Oregon Water Resources Department

MEMORANDUM

SUBJECT: Artificial groundwater recharge application LL-1964 is incomplete

DATE: 4/15/2024

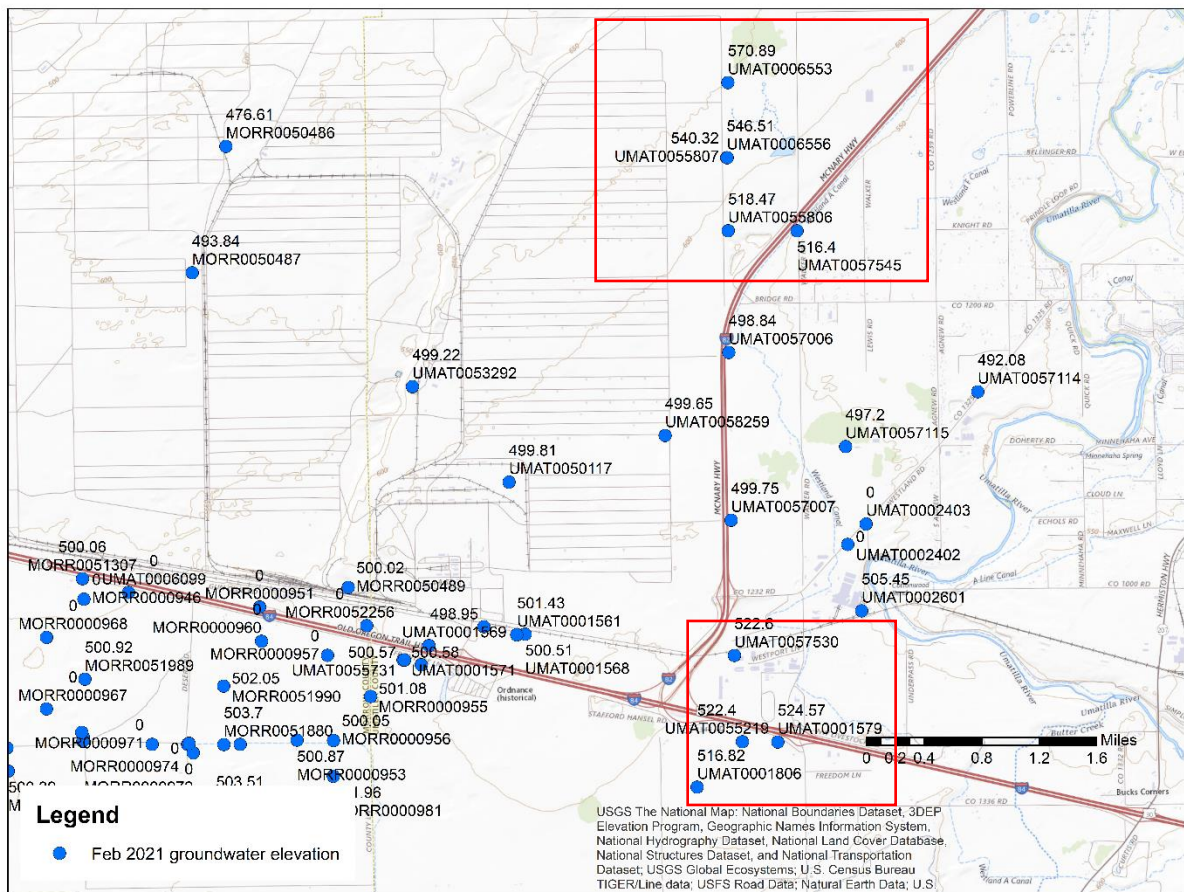
Fig 5 and Fig 6. What season does this figure depict? The contours are extended into areas where data is available but was omitted. Therefore, they fail to reflect the actual water table. For example, the wells in red boxes below are primarily located in saturated fine-grained sediments and reflect water table high points in the subject area. Omission of wells and water level data from fine-grained sediments in the catastrophic flood deposits in Figure 6, page 40 results in modeled water level elevations that deviate from measured levels by approximately 40-80 feet NE of the proposed AR site and 10-20 feet SE of the Depot.

- 5) Omission of water level data from fine-grained sediments in the catastrophic flood deposits within the model area results in modeled water level elevations that deviate from measured levels by approximately 40-80 feet NE of the proposed AR site and 10-20 feet SE of the Depot. See map above. This is not acceptable as a basis to model predictively.

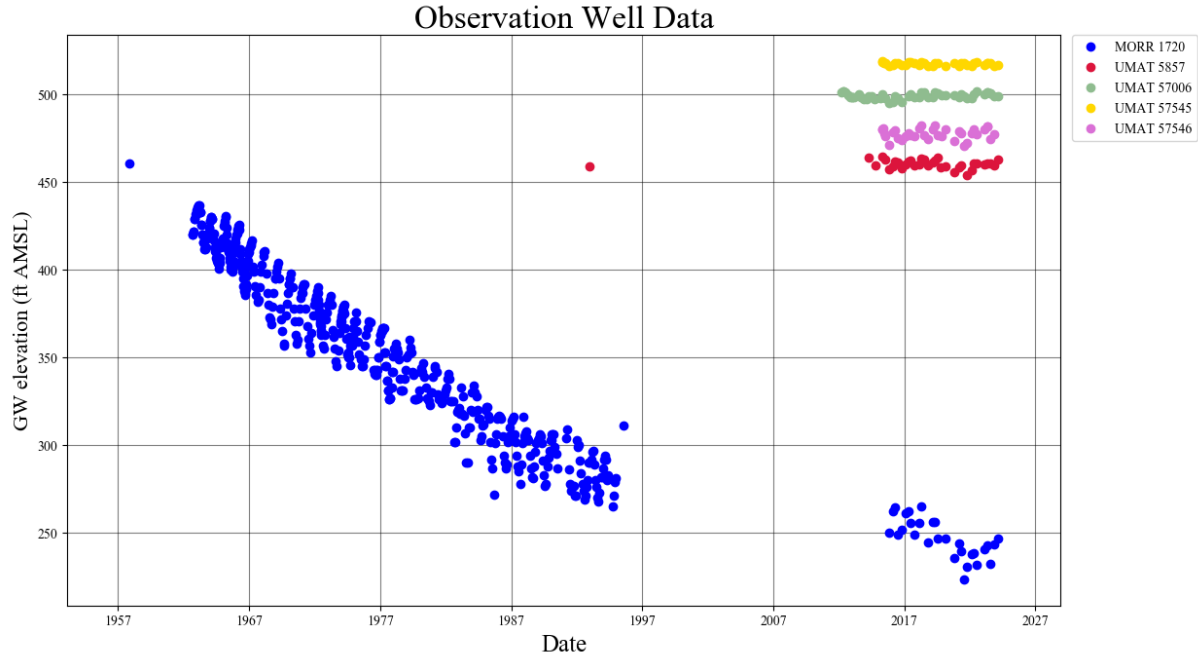
Fig 4a and 4b. What data support the Alkali Canyon depiction on cross section A-A'? Given that Alkali Canyon was emplaced before the Missoula floods and their resulting erosional features into basalt, what

geologic process would place Alkali Canyon on top of a younger erosional feature? Mechanisms aside, the hydraulic significance of erosional windows in this area is that there is a potential pathway for water to move from sediments into the Rattlesnake Ridge interbed, which lies between Elephant Mountain and Pomona.

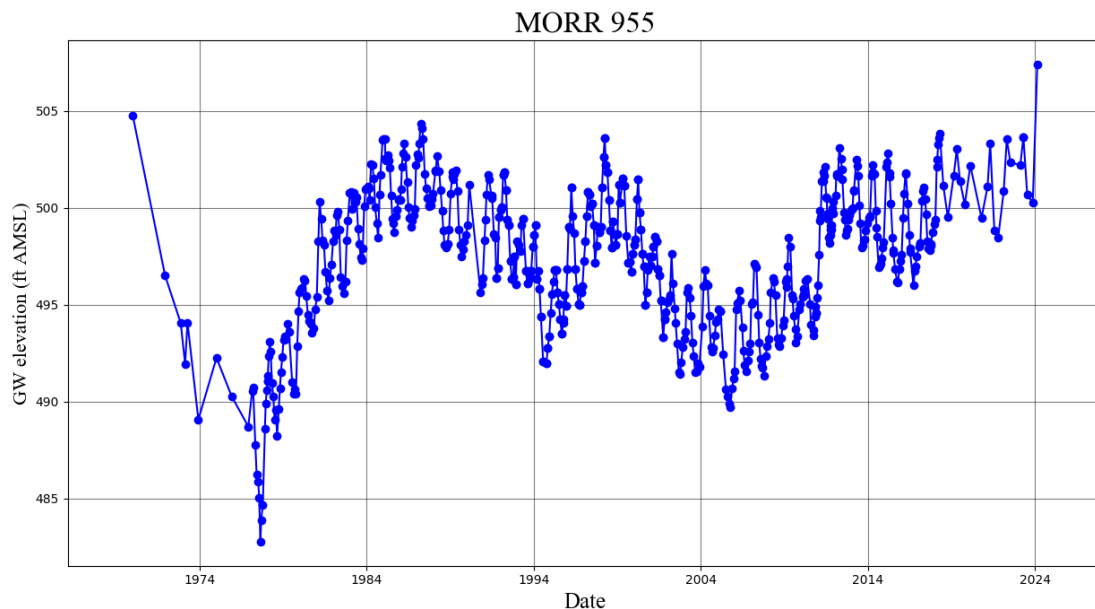
- 1) Mentioned in this section: a second AR LL may be incoming from Umatilla River to recharge at the same location. Is that contemplated as additive to the volume planned for in this Columbia River application?
- 2) There is a mention of secondary groundwater permits here with no previous mention in the application. Without knowing what (if any) recovery of stored water is contemplated, it is not possible to assess if the water level monitoring plan will be sufficient. From the perspective of impact to nearby wells, the plan should include at least one well between the recharge site and the landfill.
